STATION, RADIO, A13

TECHNICAL HANDBOOK - INDEX OF MODIFICATIONS

TECHNICAL HANDBOOK - MODIFICATION INSTRUCTION

SUB-TITLE: Reduction of r.f. amplifier cross modulation

Fig 1 - Location of additional resistor on board 1B

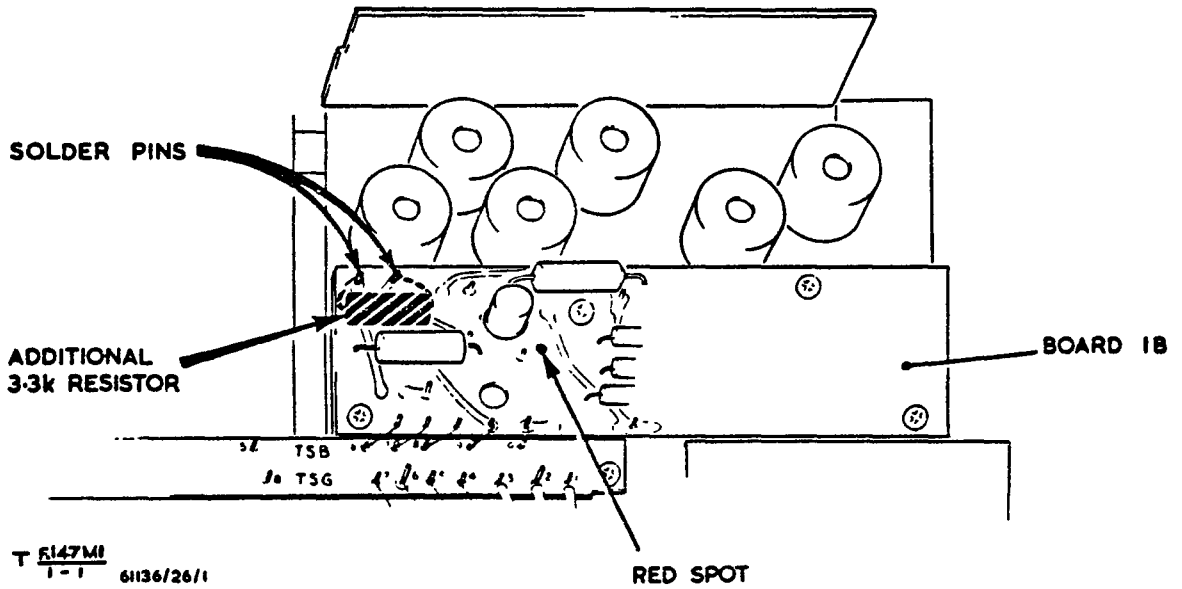
Cross modulation of the r.f. amplifier can be reduced by the addition of a resistor in parallel with R13 in the r.f. amplifier. This regulation details the action required to fit the additional resistor.

Fig 1 - Wiring changes, top of panel

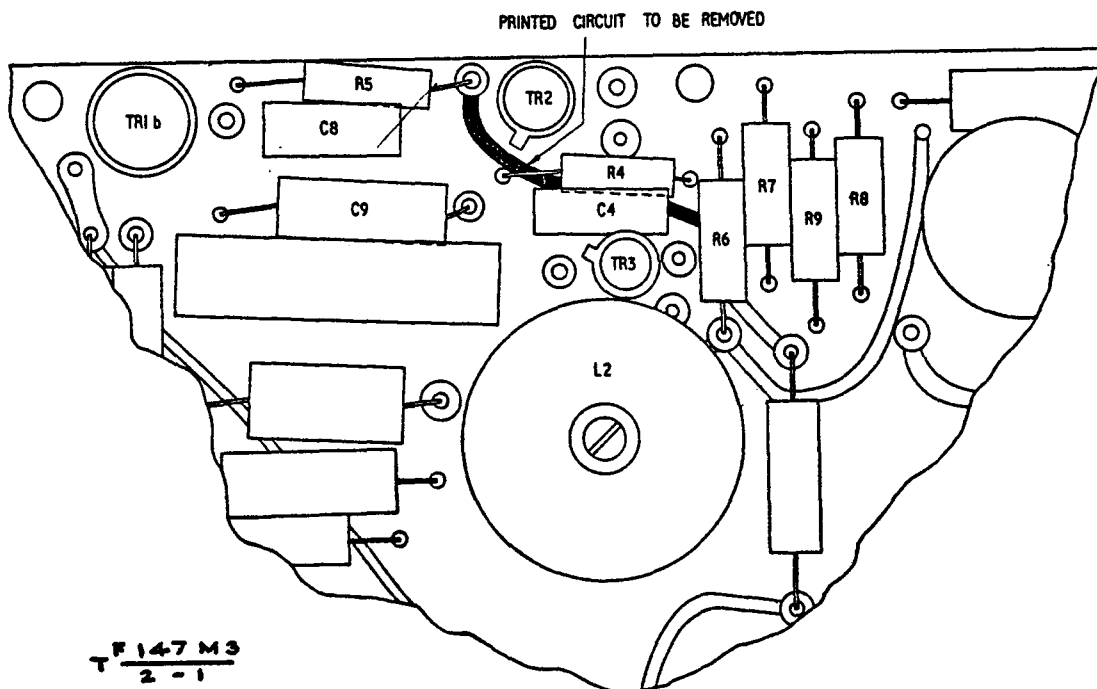
- c. Examine the new board and if unmodified proceed as in d. to f.
- d. Using a sharp knife remove the printed circuit as detailed in Fig 1 and 2, taking care not to damage any neighbouring printed circuit or components.
- e. Locate and solder in place the wiring as shown in Fig 2.
- f. Ensure that the figure 1 is painted through, without obliterating, on the modification label of the Panel electronic circuit (board 5).
- g. Replace the modified board 5 in the equipment, coating the fixing screws with varnish (8010-99-943-3454) before fastening.
- h. Replace the set into its case, carrying out drying and sealing instructions detailed in Tels F 144, para 11 to 17 inclusive.
- j. Ensure that figure 5 is struck through, without obliterating, on the equipment modification record plate.

Fig 2 - Board 17 modified component layout

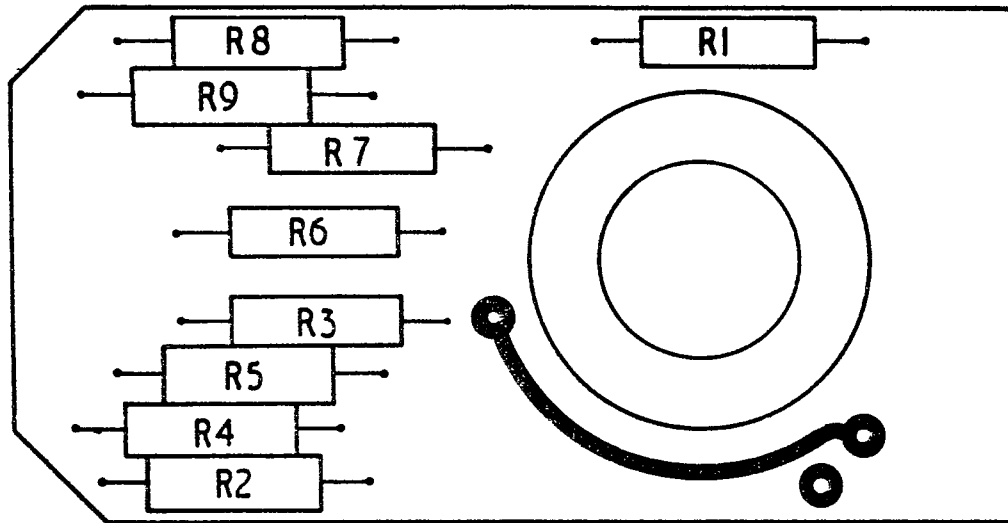
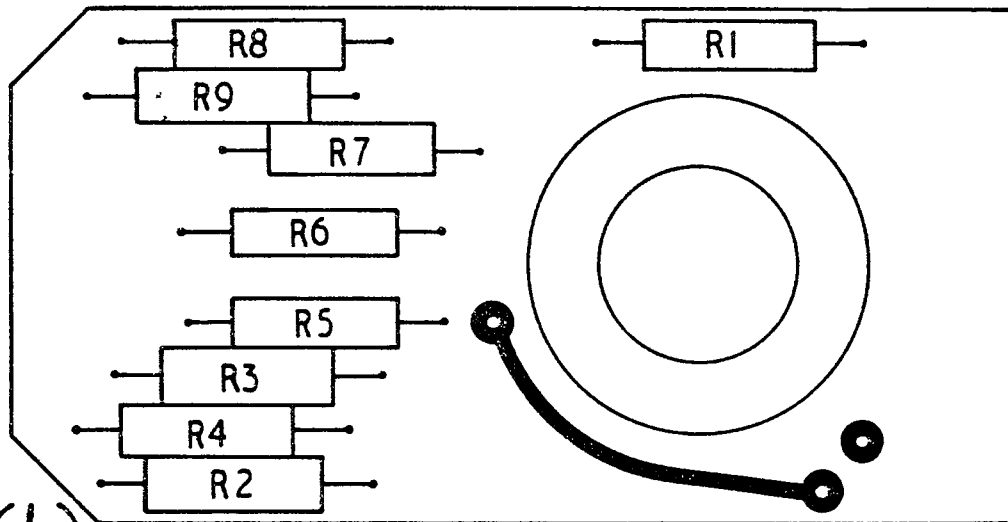
h. Using the 'Soldermaster' or a similar type of iron, remove R2, R3, R5, R6, R7 and R9 and replace them with the new resistors listed as follows:

<u>Reference</u>	<u>Existing value</u>	<u>New value</u>
17R2	82Ω	100Ω
17R3	100Ω	120Ω
17R5	120Ω	150Ω
17R6	150Ω	200Ω
17R7	270Ω	330Ω
17R9	56Ω	68Ω

Fig 1 - Modification detail

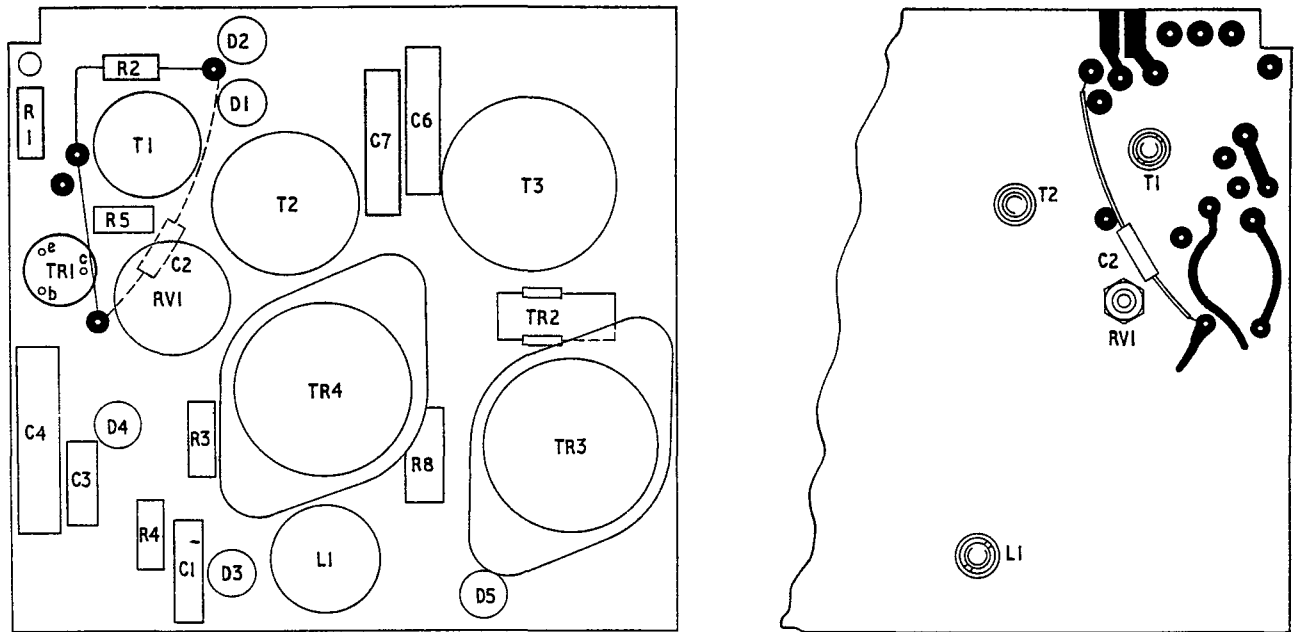
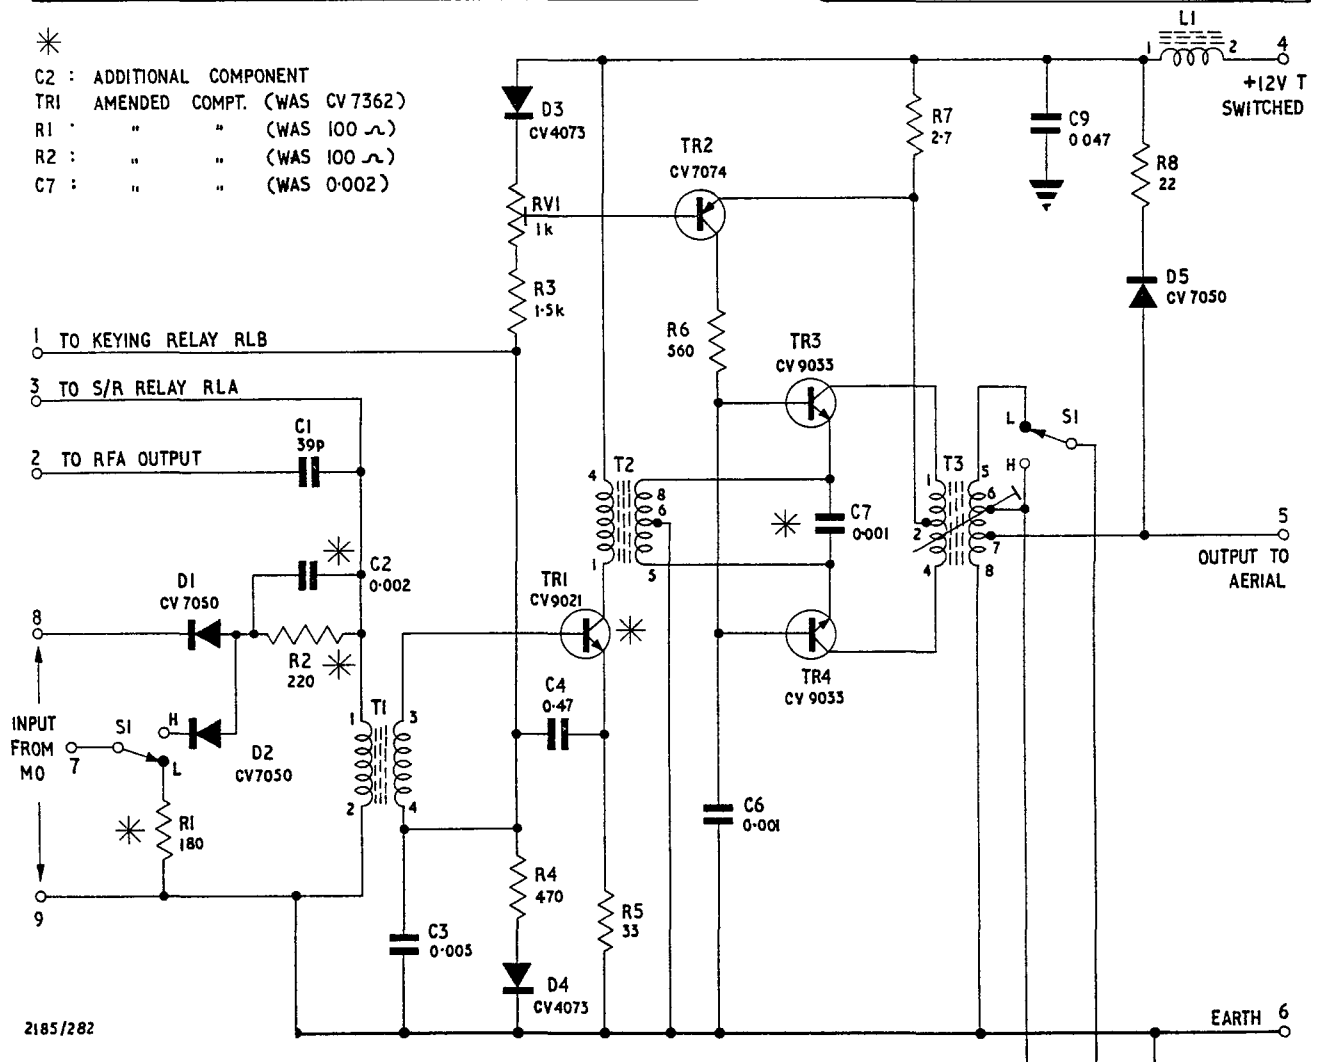
f. Unsolder and remove capacitor C7 (see Fig 1(a)).

k. Unsolder and remove resistor R2 from the underside of the board (see C2, Fig 1(b)).

m. Unsolder and remove resistor, R1, and fit the 180 Ω resistor, fixed, oxide film insulated (5905-99-012-4677), in lieu (see Fig 1(a)).

n. Unsolder the white, green and red sleeved terminations of transistor TR1 on the panel, electronic circuit; remove the transistor (see Fig 1(a)).

- *
 C2 : ADDITIONAL COMPONENT
 TR1 AMENDED COMPT. (WAS CV 7362)
 R1 : " " (WAS 100 Ω)
 R2 : " " (WAS 100 Ω)
 C7 : " " (WAS 0.002)

Fig 1a - Modification detail

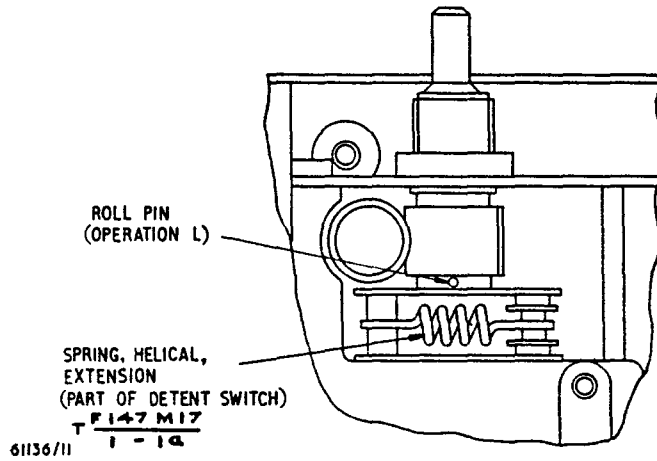
- d. Unscrew the 4 Phillips securing screws on the switch mounting plate and carefully remove the plate. Make a note of the position and quantity of shims under each corner of the mounting plate and retain for use later. Refer to Fig 1a and 1b for this and subsequent operations.

- l. Remove the roll pin from the shaft with a pin extractor and replace with a spring pin (Z1/5315-99-106-2796) as provisioned.
- m. Refit the gear and shaft assembly locating it into the cam and gear assembly. Align the hole in the cam and shaft, but before pinning with the spring pin (Z1/5315-99-106-2796) as provisioned, carry out the following check:- Use a No 4 UNC socket-head set-screw to lock the cam to the shaft. With the RANGE Mc/s switch in the fully clockwise position, turn the switch seven clicks anti-clockwise and on the next turn of the switch it should move the actuator arm. If this condition is achieved, fit the spring pin as provisioned.

Fig 1 - Board 11, modification detail

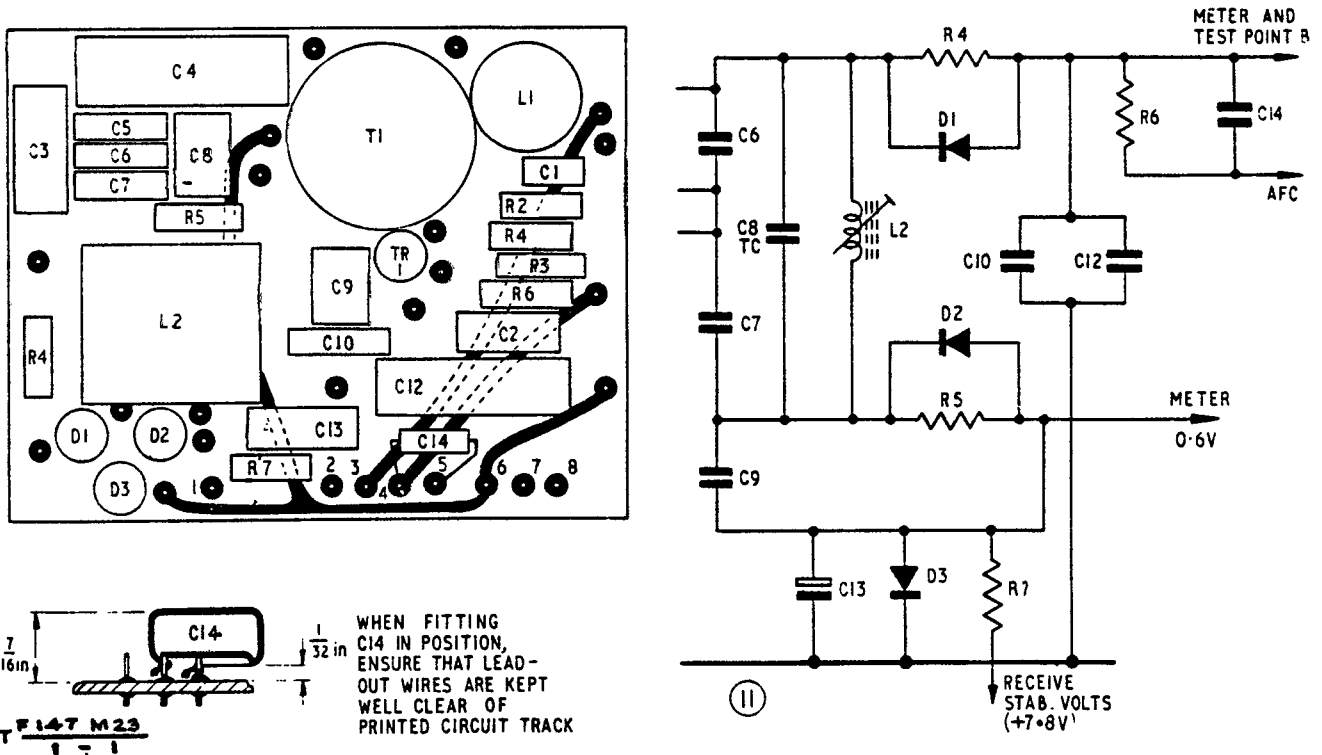
- b. Locate and remove the Panel, electronic circuit, (board 11) Z1/5820-99-101-9882, following the instructions detailed in Tels F 144 para 35.
- c. Solder the capacitor, fixed, mica dielectric, 1000pF (Z1/5910-99-999-1867), new circuit designation 11C14, between pins 4 and 5 on the Panel, electronic circuit (see fig 1).

- d. Using an approved black waterproof drawing ink, add the coding 'C14' adjacent to the new component, and when coding is dry, cover it with a thin coat of varnish (H1/8010-99-943-3454), ensuring that the ink and/or varnish does not encroach on the printed circuit or terminals.
- e. Record the embodiment of this modification by painting through, with a diagonal line the figure 1 on the mod record label of board 11 with paint, finishing, red (H1/8010-99-910-7033).
- f. Replace board 11 applying a thin coat of Varnish, insulating, red (H1/8010-99-942-8917) to the underside of the screw heads before assembly.
- g. Record the embodiment of this modification by striking through, with a diagonal line the figure 14 on the Transmitter, receiver, radio A13 (Z1/5820-99-949-6353) equipment mod record plate.

Fig 2 - Board 13, modification detail

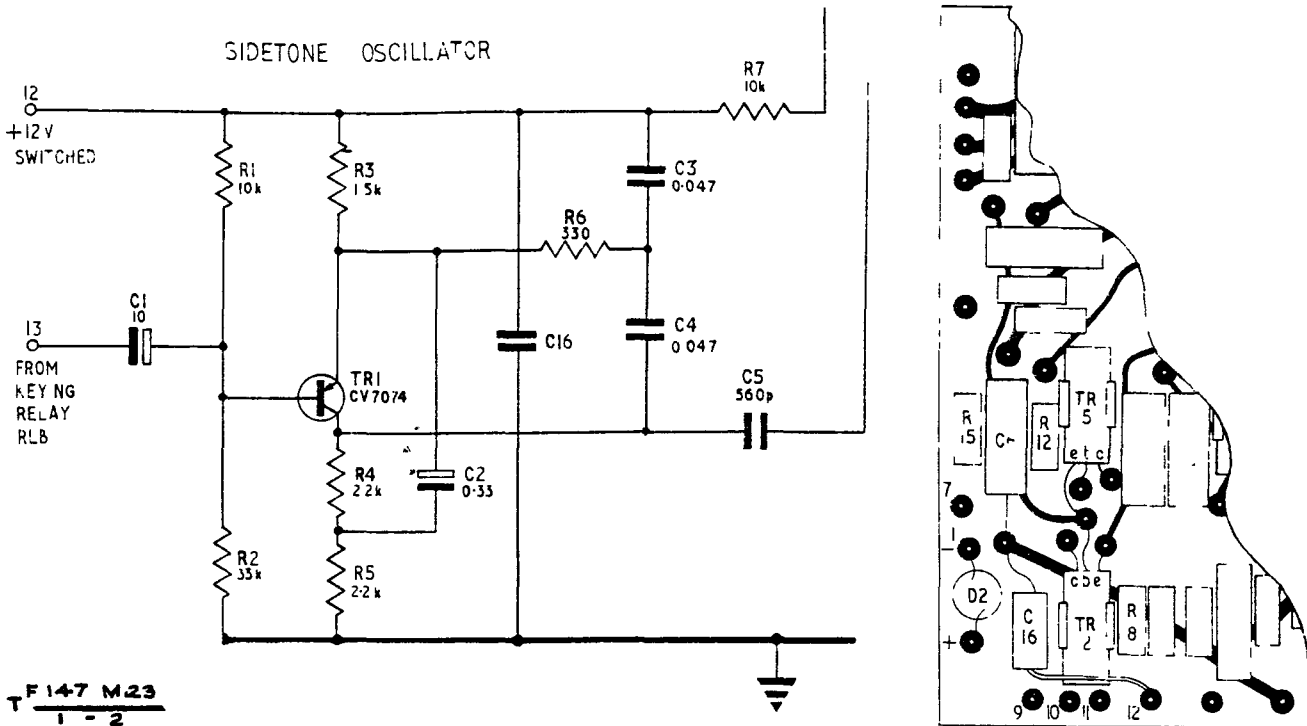
k. Solder the capacitor, new circuit designation 13C16, between capacitor C6 and pin 12 on the Panel, electronic circuit (see Fig 2).

l. Using an approved black waterproof drawing ink add the coding 'C16' adjacent to the new component and when the coding is dry, cover it with a thin coat of Varnish (H1/8010-99-943-3454), ensuring that the ink and/or varnish does not encroach on the printed circuit or terminals.

Fig 2 - Part of front panel, component layout, after modification

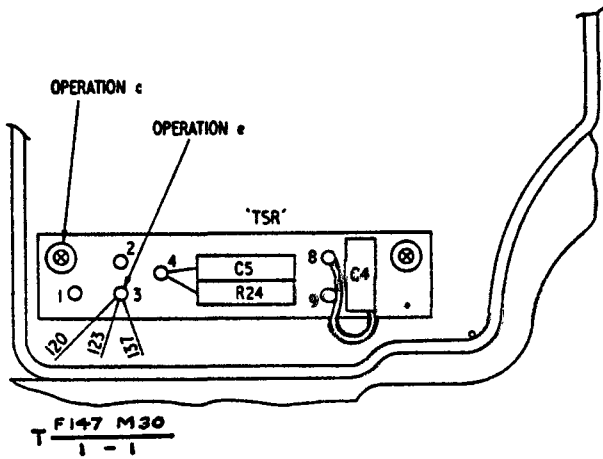
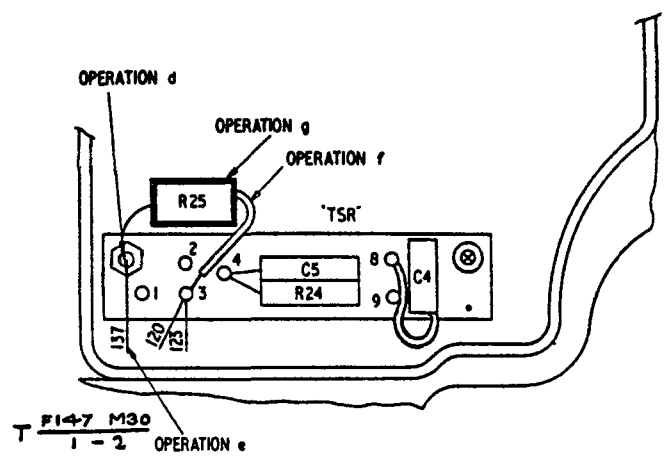
- c. Remove and dispose of the board securing screw on the left hand side of terminal board TSR. See Fig 1.
- d. Apply a thin coat of Dulux, red, varnish, insulating (H1/8010-99-942-8917) to the threads of the Insulator, stand-off (Z/5970-99-106-8253) provisioned in the mod kit and fit the stand-off insulator in place of the screw removed in operation c.

Fig 3 - Part of front panel circuit, after modification

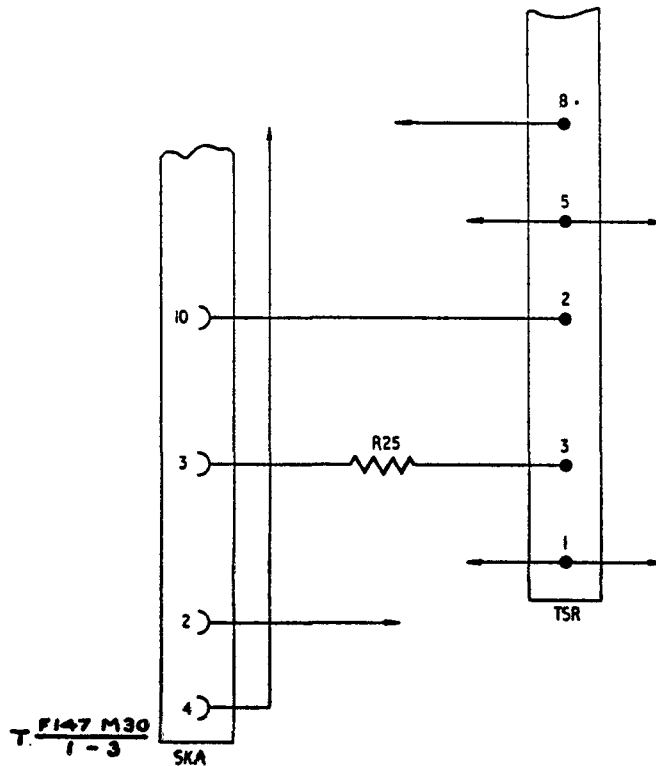
- a. Page 1009, Fig 2504: Add the additional resistor R25 as illustrated in Fig 3 of this instruction.
- b. Page 1029, Fig 2524: Show changes as illustrated in Fig 2 of this instruction.
- c. Page 1030, Fig 2525: Wire No 137 on SKA
Delete: 'TSR-3'
Insert: 'R25'

Fig 1 - Section of film scale assembly after modification

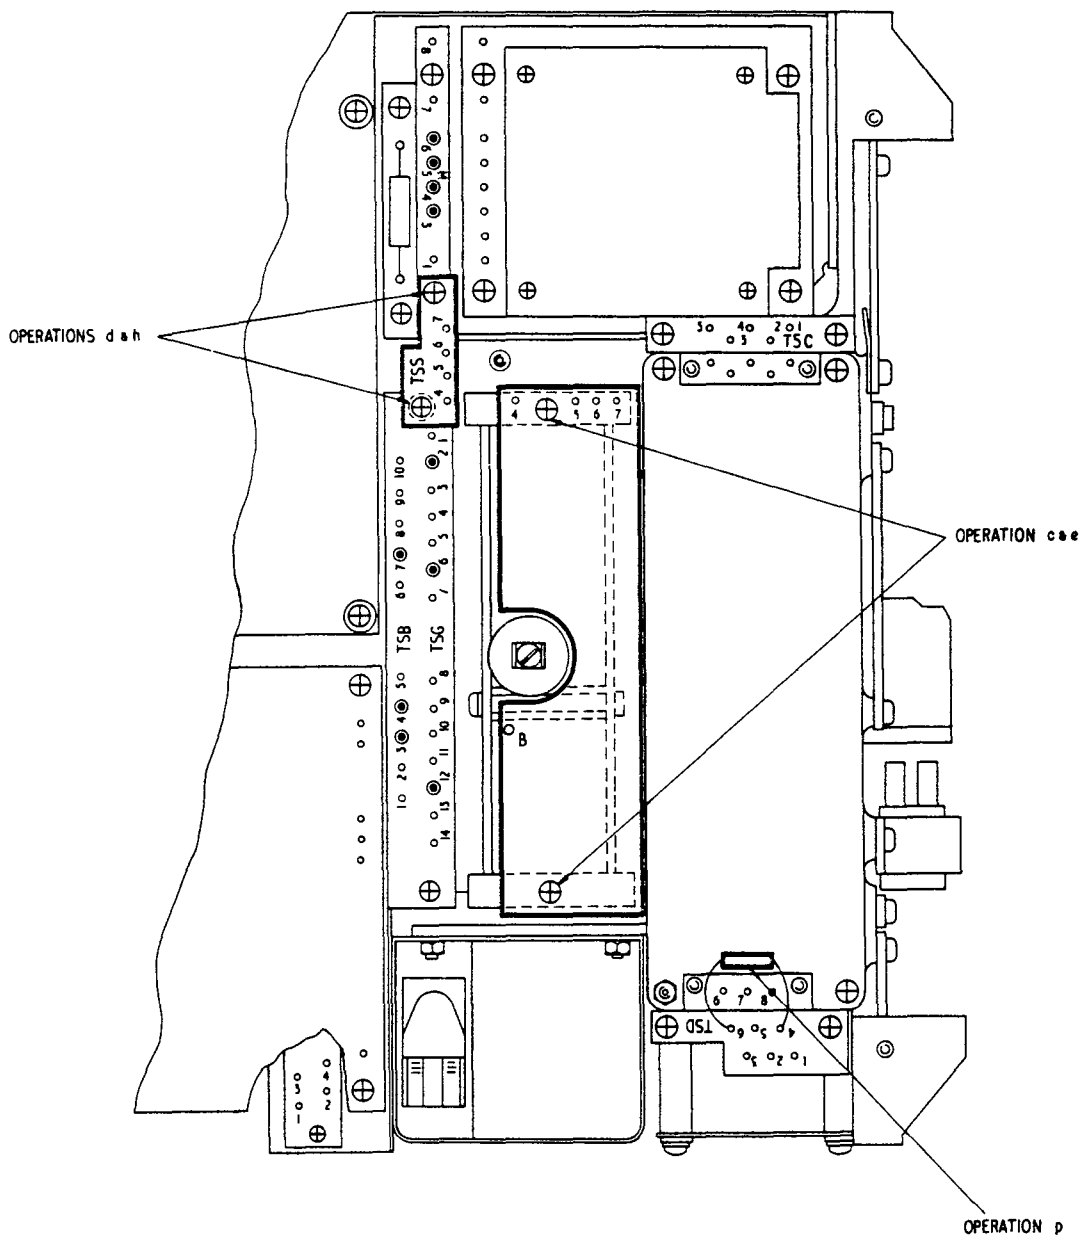
c. Locate and remove the two cross-headed screws and washers securing the retainer, electronic circuit panel (5820-99-102-4527) to the film scale casting. Discard the screws and retain the washers (see Fig 1).

Fig 2 - Fitting of resistors and link wires

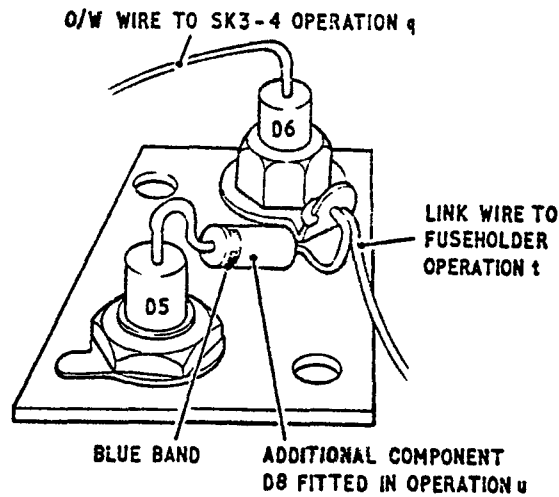
- g. Connect a 5 in. length of wire, electrical between the junction of R23, R24 and the negative junction of C23, C24 (Fig 2).
- h. Remove the relay and equaliser sub-assembly (Tels F 144 para 180-185).
